Date: 27th January 2022

1 - Fire service access and facilities

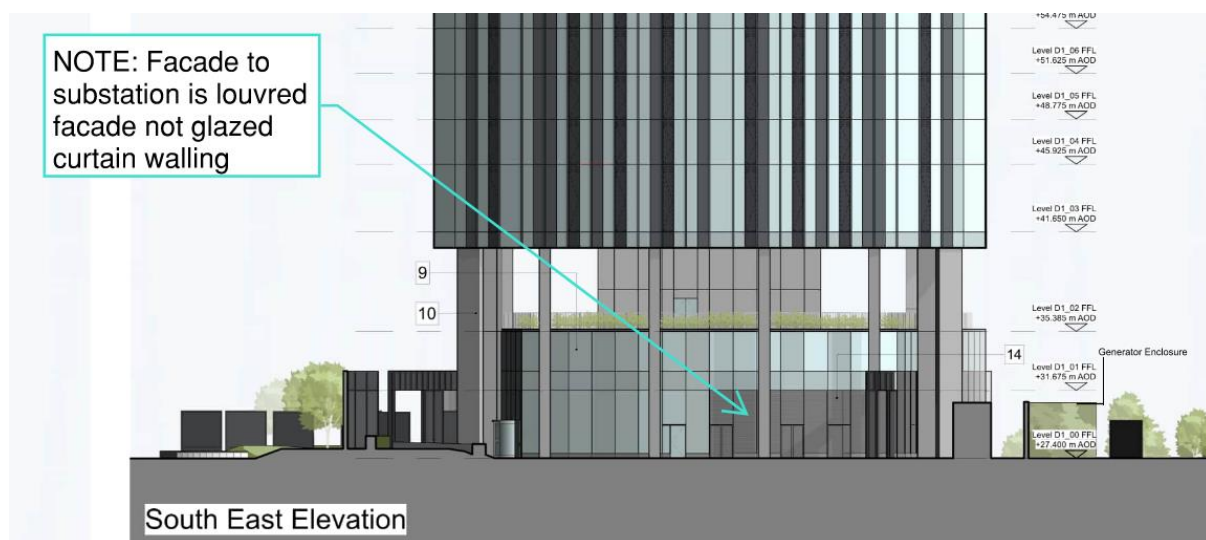
3.2 - The ground floor plan drawing of building D1 appears to show glazed external walls of the electricity substation and 'move in' store, immediately adjacent to the entrance to a firefighting shaft. This could allow fire to spread from the adjoining accommodation to the firefighting shaft. Likewise, an entry to the firefighting shaft in building C1 appears to adjoin glazed sections of external walls. Resolving this issue may affect land use planning considerations such as the appearance of the building.

For reference, it is noted that the area of Building D1 elevation associated with the substation and 'move in' store will be louvred panels, rather than glazing (see elevation extract below).

Notwithstanding, in each scenario referred to above, the façade of the accommodation adjacent to the stair discharge door does not form an internal angle to the stair door (i.e. risk of received radiation is limited due them being on the same plane) and in the event of a fire within the adjacent accommodation the Fire Service would not be required to utilise the firefighting shaft (i.e. as they could fight the fire directly from outside) and any occupants
